# UNITED STATES PATENT AND TRADEMARK OFFICE

10/539,160

<b>Office Action Summary</b>	<b>Application No.</b> 10/539,160	<b>Applicant(s)</b> GRADEL ET AL.	
	<b>Examiner</b> JAMES L. SWIGER	<b>Art Unit</b> 3733

## **DETAILED ACTION**

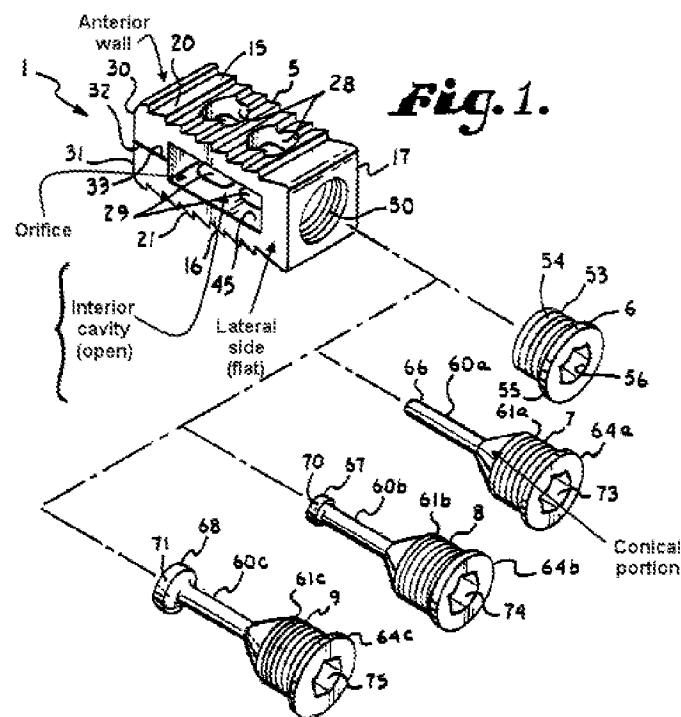
Jackson discloses an intervertebral implant (1) comprising a solid biocompatible material implant body (5) having a tubular general structure delimited by an upper wall (15) and a lower wall (16), two opposite lateral walls (see Figure 1 below) that are plane and slightly divergent toward the front, and a posterior wall (17) with a threaded axial hole (50), with a single interior cavity (see Figure 1 below; paragraph 0036) providing communication between orifices provided in the upper wall (15) and the lower wall (16), wherein: the upper (15) and lower (16) wall each comprise a respective single large upper or lower orifice (45, 46), an interchangeable compression plug (6, 7, 8, 9; paragraph 0034); the interior cavity is closed toward the front by an anterior wall (see Figure 1 below), the width of the implant (1) defined by the lateral walls is less than its

height defined by the upper and lower wall. It is noted that Jackson's implant could also be cylindrical in shape (paragraph 0011), therefore allowing the width of the implant to be less than its height. Because of the upper and lower orifice, the interior cavity is open over the whole of its width between the lateral walls and over the whole of its length between the posterior and anterior wall (see Figure 1 below).

The interchangeable compression plug (6, 7, 8, 9) comprises a conical interior end portion (see Figure 1 below). The interchangeable compression plug (6, 7, 8, 9) and the threaded axial hole (50) that receives it have a diameter substantially equal to the width of the interior cavity in the vicinity of the posterior wall (see Figure 1 below). The interchangeable compression plug (6, 7, 8, 9) has a length such that, at the end of screwing it into the threaded axial hole (50) that receives it, its interior end portion penetrates the interior cavity to a distance of at least one quarter of the length of said interior cavity (paragraph 0041-0043). The implant (1) has at least two interchangeable compression plugs (6, 7, 8, 9; paragraph 0034) having different lengths (paragraph 0041). The anterior wall includes an eccentric threaded hole of smaller diameter (paragraph 0038). The upper and lower larger wall include annular toothed anti-expulsion ribs (paragraph 0037). The interchangeable compression plug is made of titanium (paragraph 0011). The upper (15) and lower wall (16) are each of conical general shape and the upper and lower orifice are each bordered at their anterior and posterior ends by a flat perpendicular to the lateral walls (see Figure 1 below).
